### REMARKS

Serial No. 09/629,569  
Reply to Office Action of 11/24/03

DOCKET: ENS-015-PAP  
Date: February 24, 2004

FIGURE 3

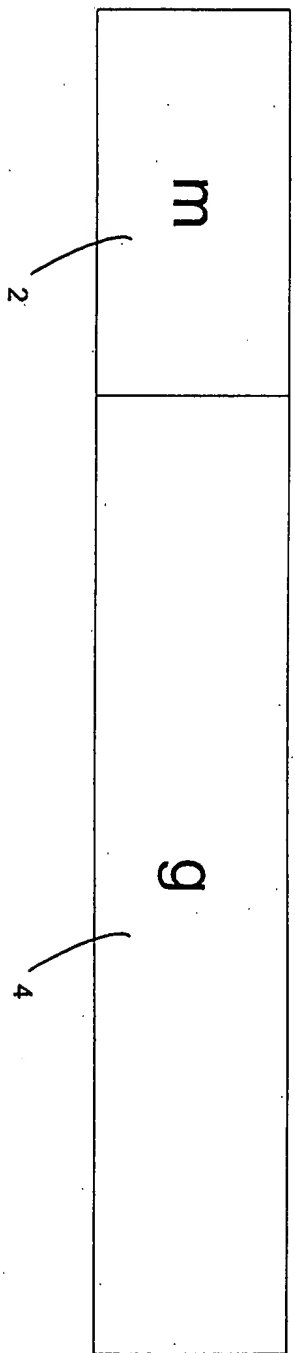
In section 1 of the current Office Action, the Examiner objects to FIGURES 1-3 for failing to indicate that they are prior art. Accordingly, attached hereto are two drawing sheets showing proposed changes to FIGURES 1-3 in red, together with two replacement drawing sheets.

(PRIOR ART)
